Project Name: Tatanka Trail

Project Number: 24-27631

Architect/Engineer: ISG

End of Addendum No. 01

C0-25

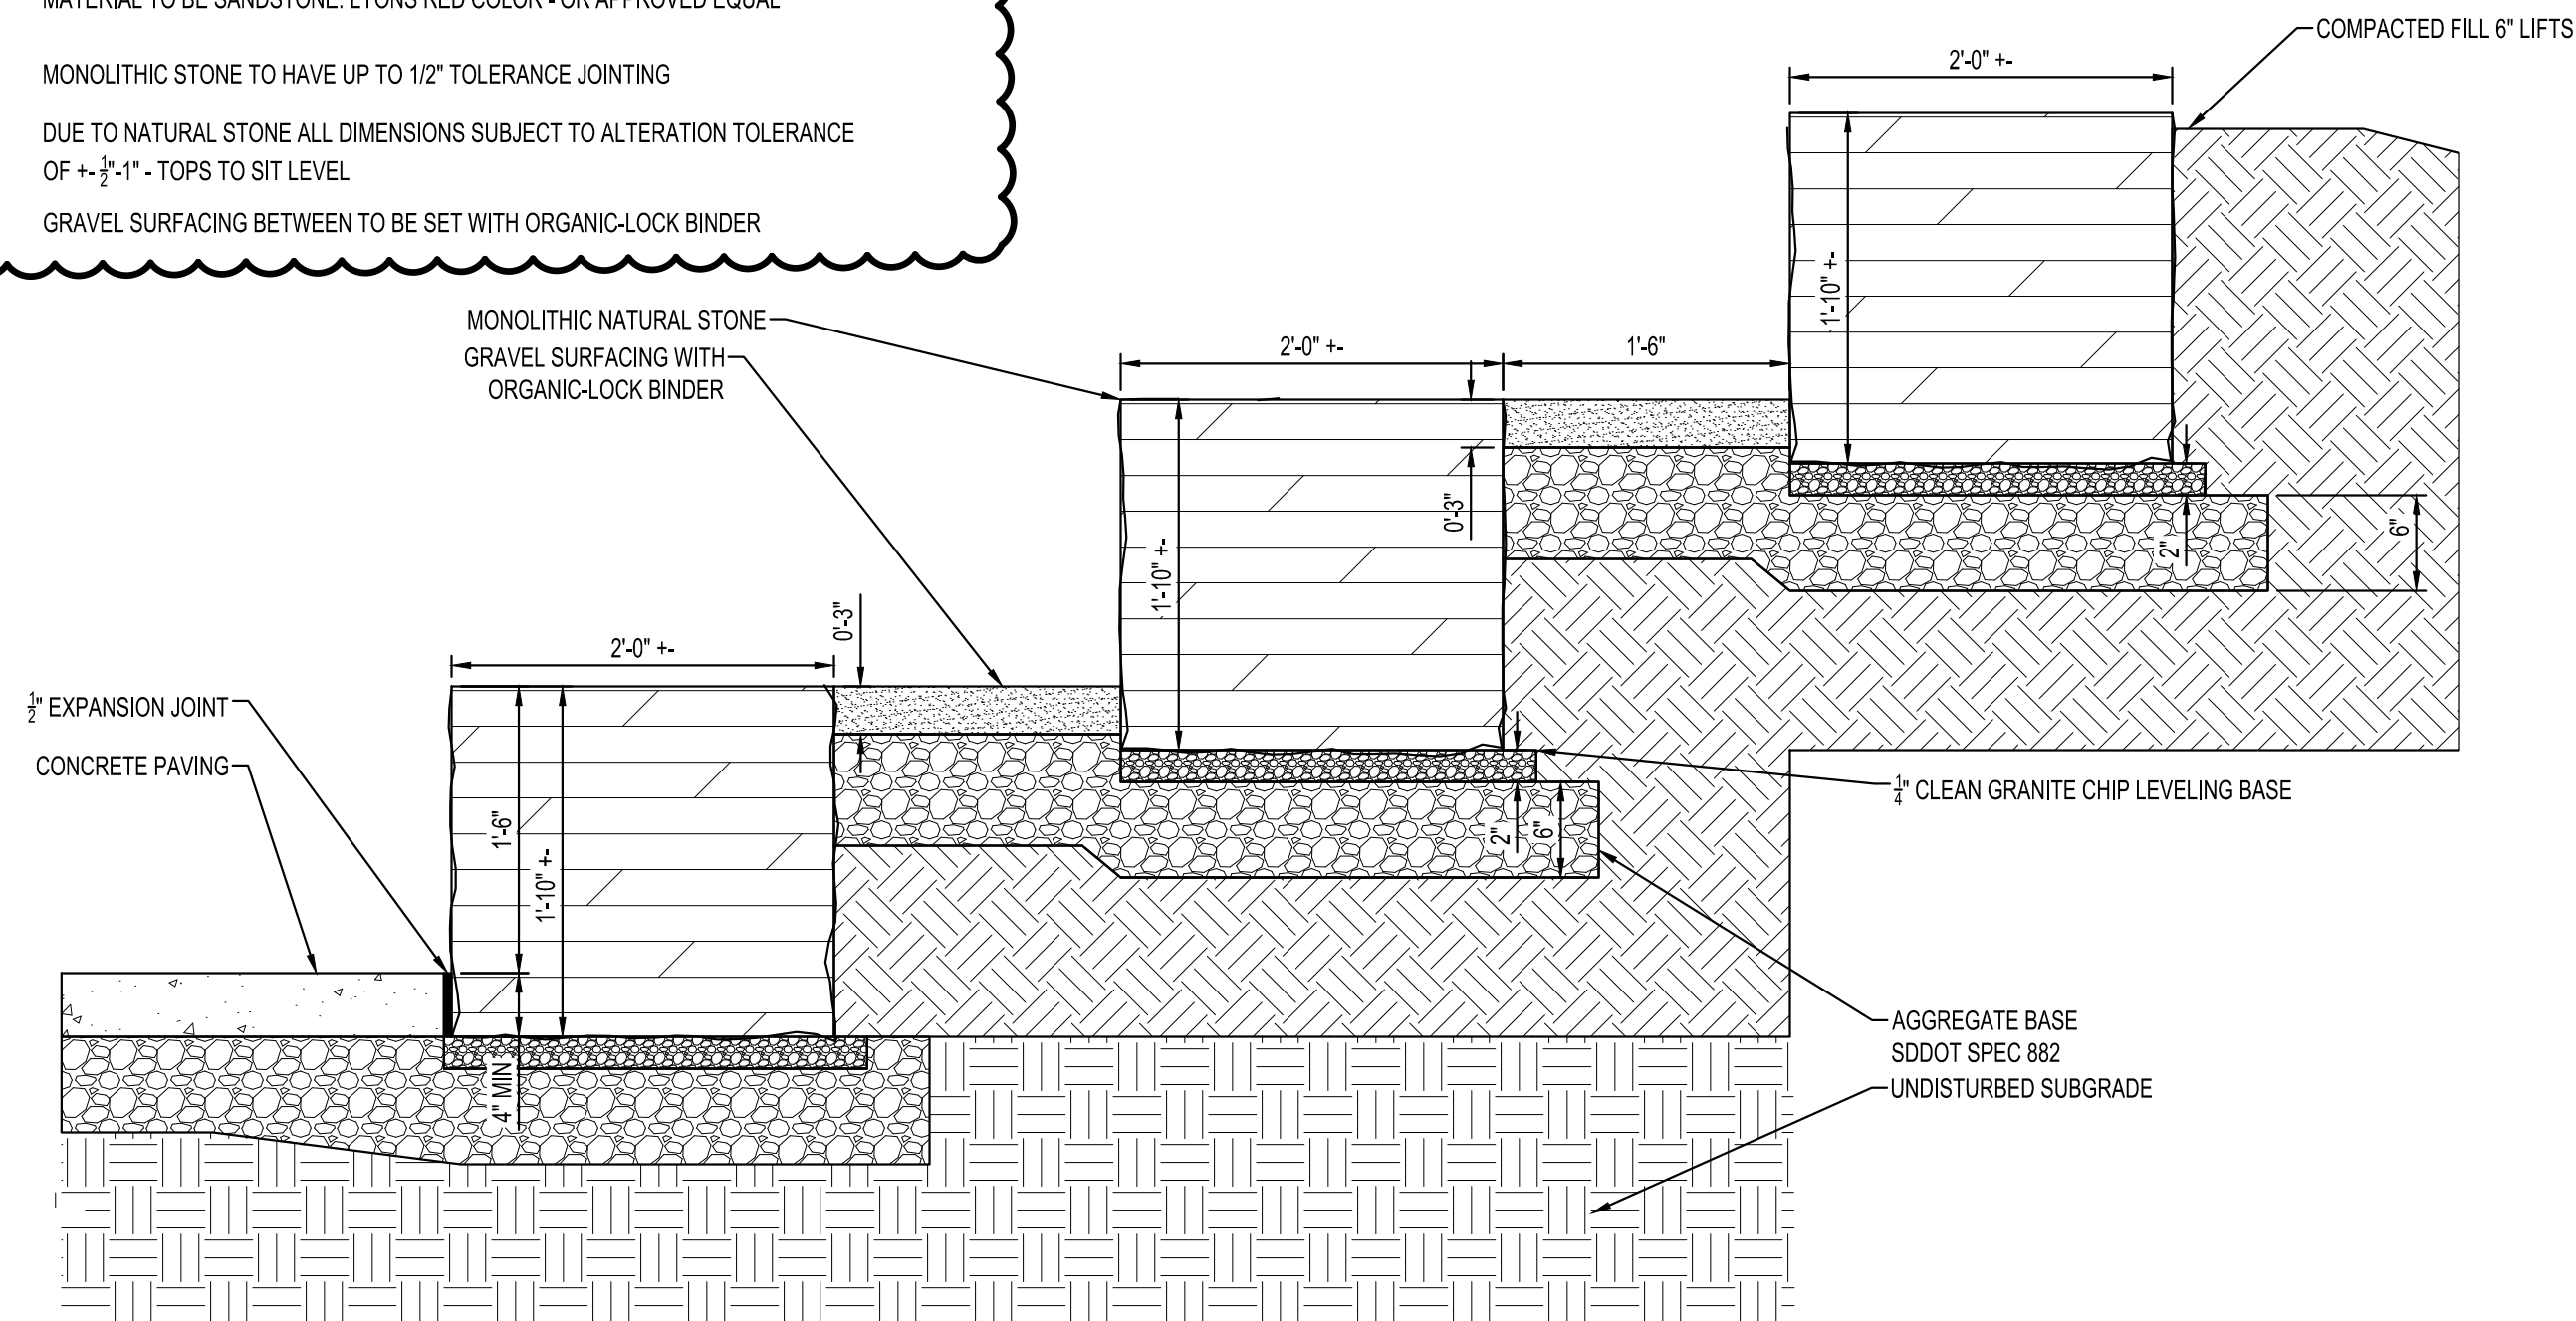
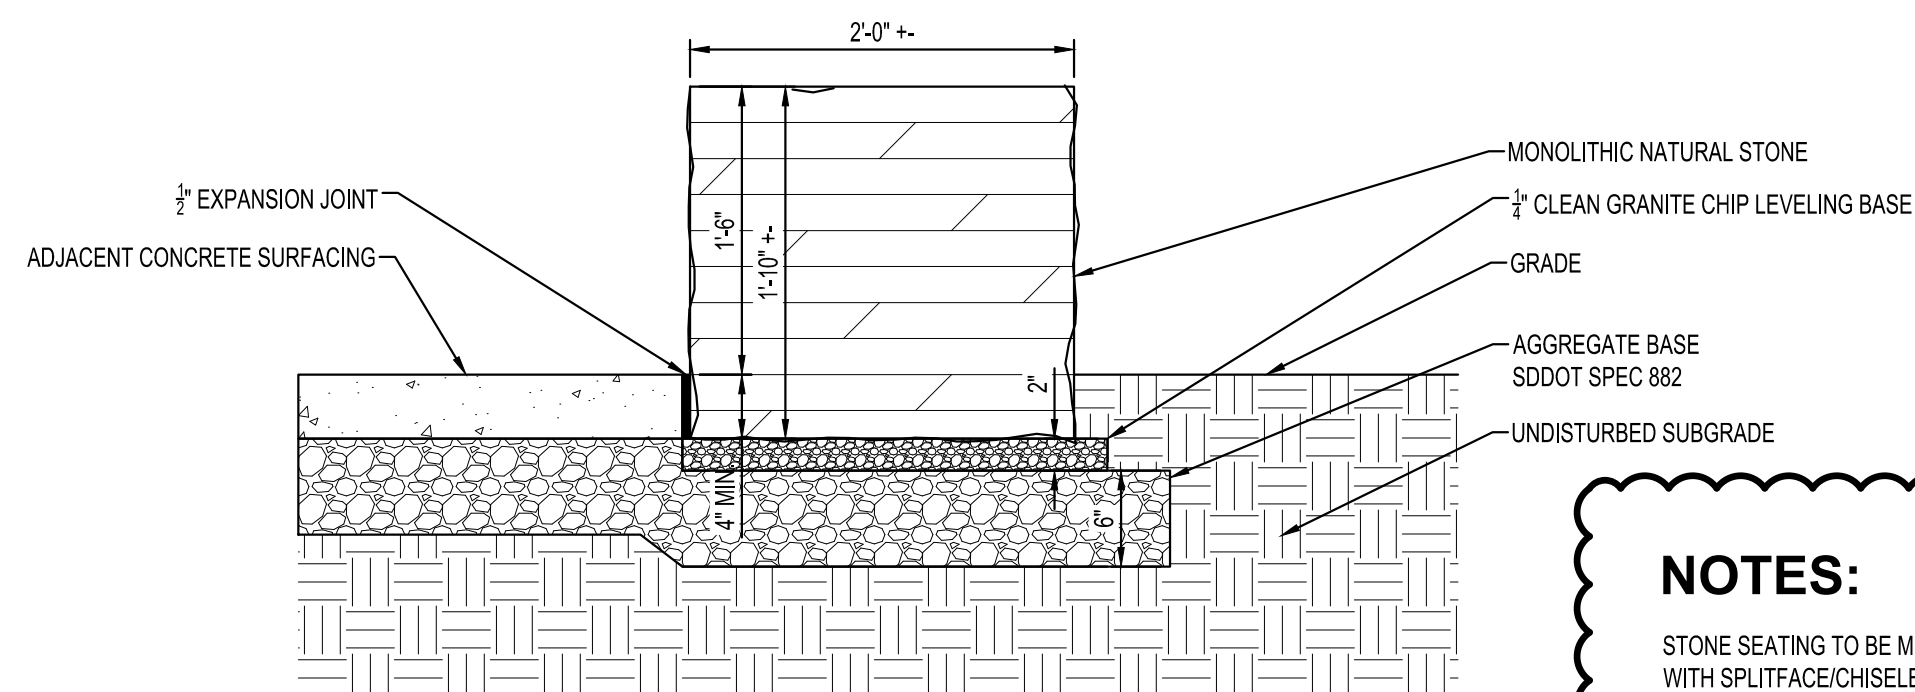
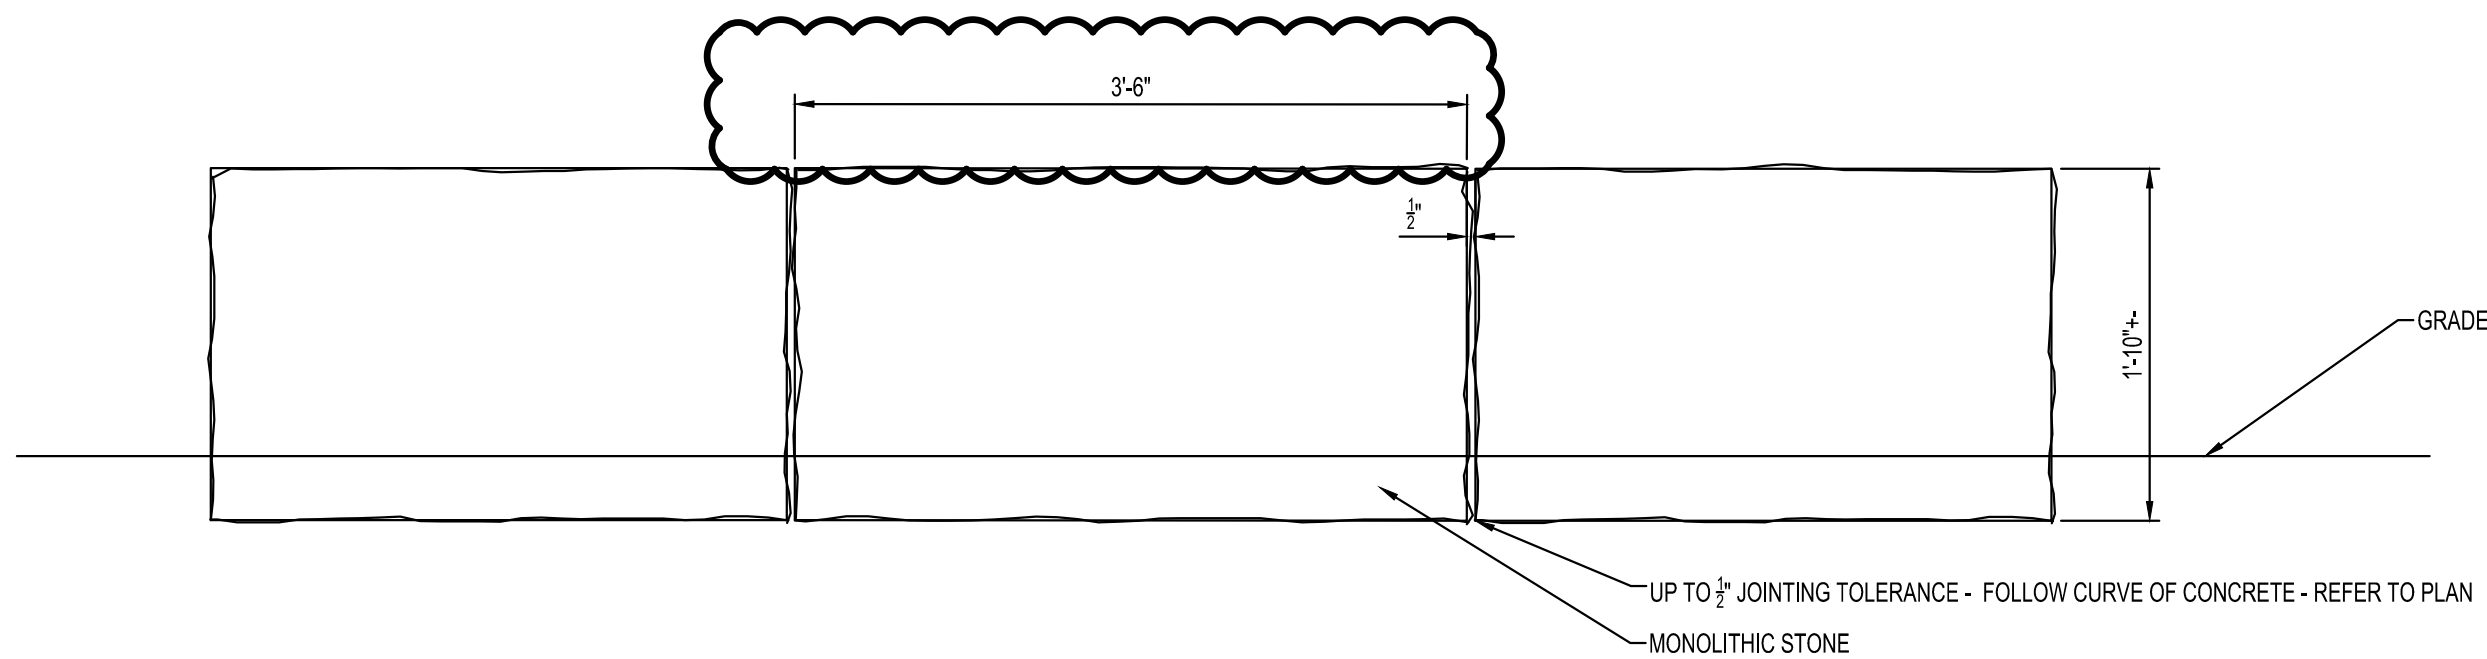
1. Refer to revised Plan Sheet C0-25 Site Details Alt 1
 - a. Added dimensions callout
 - b. Revised detail notes
2. Refer to revised Plan Sheet E7-10 – Site Lighting
 - a. Add handhole HH1 to plan
 - b. Add linework showing diagrammatic connections between handholes and electrical panel
 - c. Add labels to currently drawing handholes (HH2-HH4)
 - d. Add keynotes G and H
3. Refer to revised Plan Sheet E7-11 – Site Lighting – Alt 1
 - a. Add handhole HH1 to plan
 - b. Add linework showing diagrammatic connections between handholes and electrical panel
 - c. Add labels to currently drawing handholes (HH2-HH4)
 - d. Add keynotes G and H
